October 6, 2008

Re: Meeting on CARB's Comparison Document of Natural Gas vs. Diesel
(August 10, 2008)

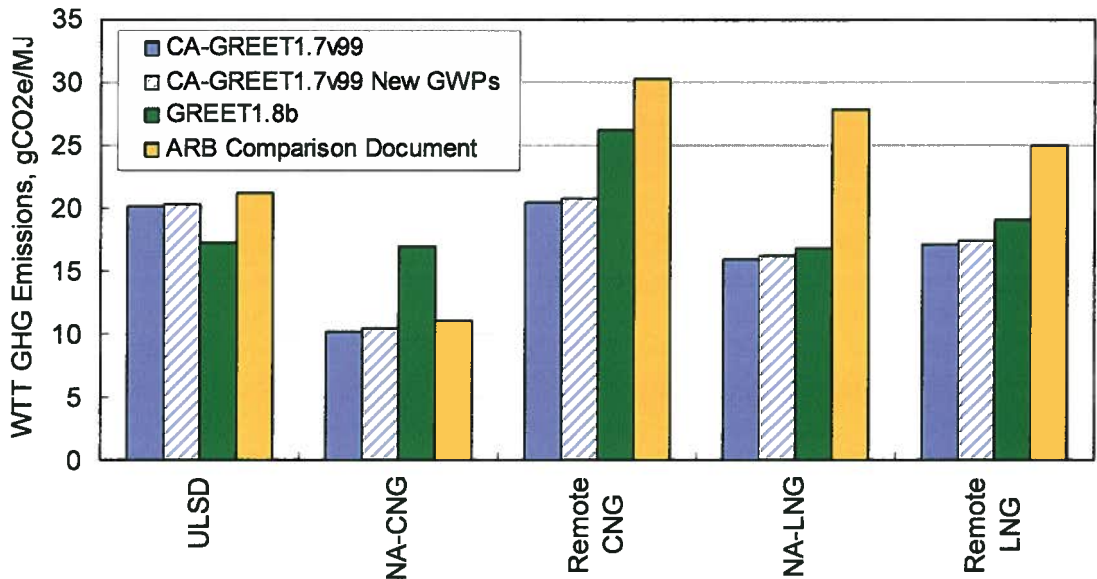
Clean Energy is also concerned that the values presented in the ARB Comparison document are significantly different than the values resulting from the AB1007 analysis and from the ULSD and CNG pathway documents posted on the LCFS website. We understand that the first CA-GREET model posted on the LCFS website is based on GREET1.7 while the soon to be released ARB version of the CA-GREET model is based on GREET1.8b. However, the only change for natural gas fuels in the new version of the GREET model is the global warming potential (GWP) factors for CH₄ and N₂O. Figure 1 below compares the WTT values produced by CA-GREET1.7 v99 with the old and new GWP values. The updated GWP factors minimally impact the results for NG fuels.

Also shown in the figure are the values generated by GREET1.8b with all Argonne National Lab default values, including the U.S. average electricity mix. The ULSD values are markedly lower because of the increased refining efficiency values. The CNG values are higher than the CA-GREET values, mainly because of the higher pipeline leak rate assumption. The LNG values are higher than the CA-GREET values largely due to poorer boil-off recovery efficiencies.

Finally, the values presented in the ARB Comparison document are shown. The ULSD and NA-NG CNG values are higher than those in the pathway documents posted on the LCFS website. The remote CNG values and the LNG values are substantially higher than the CA-GREET and GREET1.8b values. To better understand the underlying assumptions in the ARB analysis, Clean Energy requests that ARB provide the version of GREET utilized to generate the results presented in the Comparison document. If this level of transparency is not feasible, at a minimum we request the following:

- Electricity Mix for each case
- ULSD Case
 - Crude recovery efficiency
 - Crude transport modes and miles for each mode
 - ULSD refining efficiency
 - Refining non-combustion emissions

- ULSD transport modes and miles for each mode
- For all NG Fuels:
 - NG Recovery efficiency
 - Vented methane in recovery %
 - Processing efficiency
 - Vented methane in processing %
